Groundwater Transfer Review Summary Form

Transfer/PA # T- 14771

Ground Water Review Form:

Application: T-14771

Map

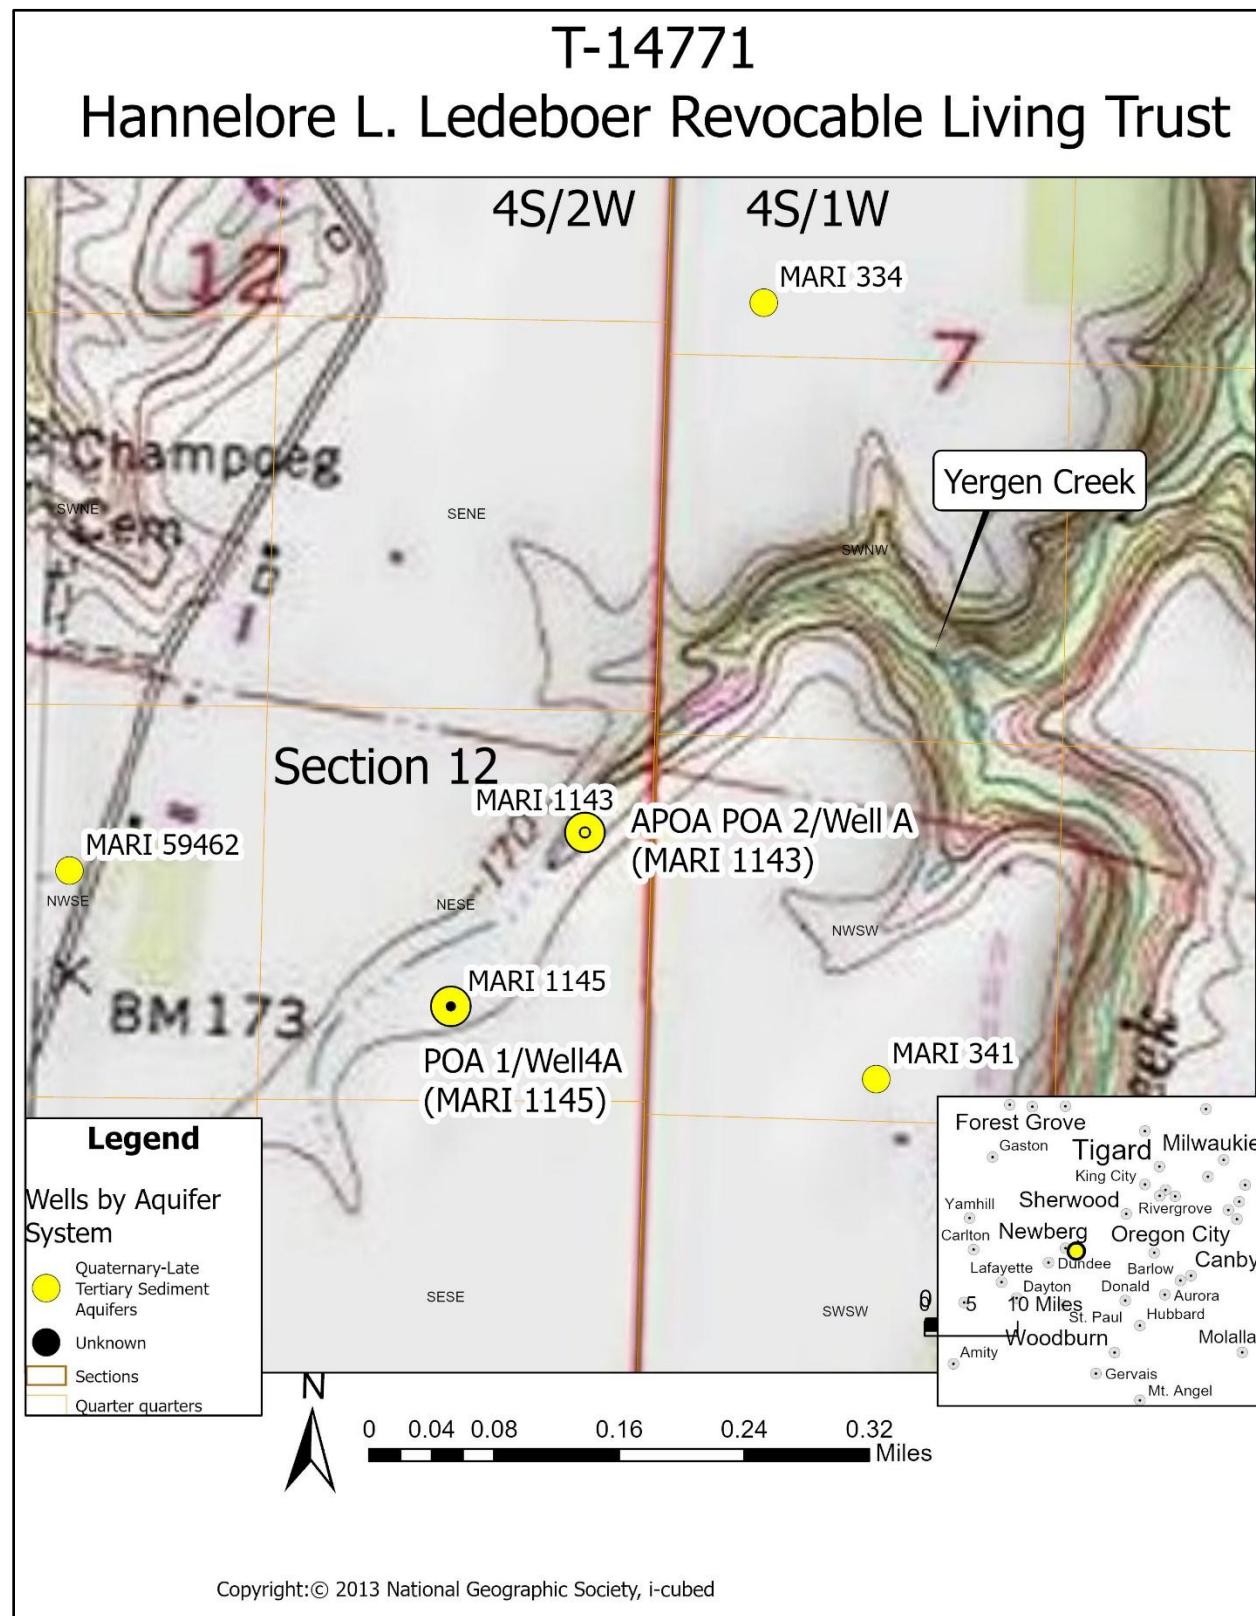
Yes No Comments: The APOA, Well A (MARI 1143) is closer to MARI 341, a POA under Certificate 53064 with priority date 4/8/1975. The reduced intervening distance is likely to result in an increase in interference with MARI 341.

Yes No Comments: The APOA, Well A (MARI 1143), is closer to Yergen Creek. The reduced intervening distance is likely to result in an increase in interference with Yergen Creek.

Theis Interference Analysis

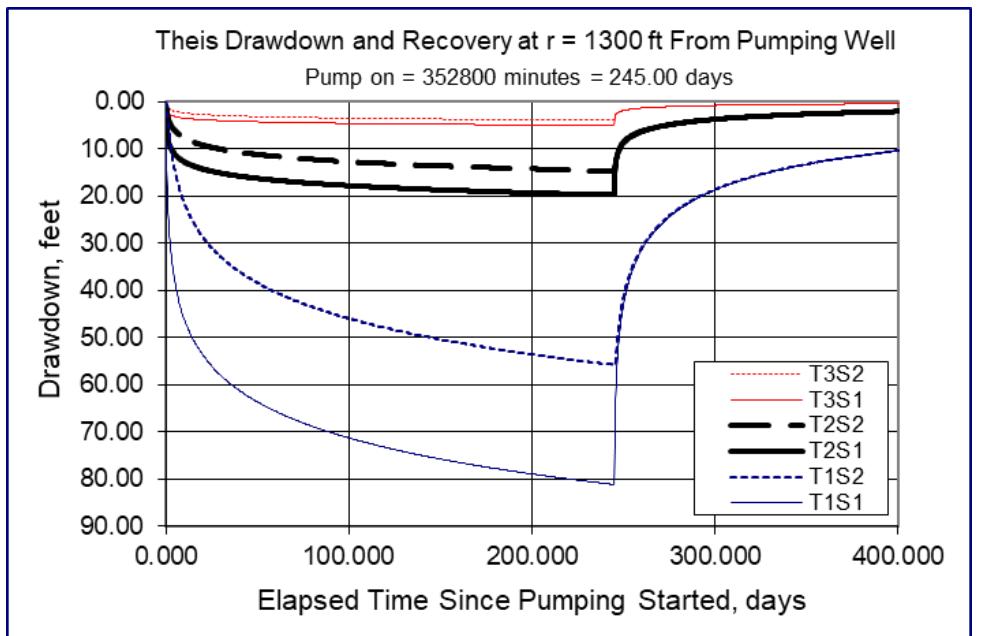
Yes No If yes, explain: The Theis (1935) solution for drawdown was used to assess the potential for injury to MARI 341 (see attached Theis Interference Analysis). Pumping by the APOA, Well A (MARI 1143), is not likely to result in MARI 341 not receiving the water to which it is legally entitled.

Input Data:	Var Name	Scenario 1	Scenario 2	Scenario 3	Units	
Total pumping time	t		245		d	
Radial distance from pumped well:	r		1300		ft	Q conversions
Pumping rate	Q		0.77		cfs	345.58 gpm
Hydraulic conductivity	K	2.18	10.9	50	ft/day	0.77 cfs
Aquifer thickness	b		220		ft	46.20 cfm
Storativity	S_1		0.0001			66,528.00 cfd
	S_2		0.001			1.53 af/d
Transmissivity Conversions	T_f2pd	479.6	2398	11000	ft ² /day	
	T_ft2pm	0.33305556	1.66527778	7.63888889	ft ² /min	
	T_gpdft	3587.408	17937.04	82280	gpd/ft	Recalculate

SWL	48	ft bls	Woodward et al., 1998
Aquifer Bottom	297	ft bls	Woodward et al., 1998; MARI 59462
Available Water Column	249	ft	Aquifer bottom-SWL
Pump Height Above Bottom	5	ft	Estimate
NPSHa	5	ft	Estimate
Drawdown	52	ft	Estimated from drawdown reported on MARI 341
Minimum Water Column	62	ft	Estimated Drawdown + NPSHa + Pump Height
Injury	187	ft	Available Water Column-Minimum Water Column
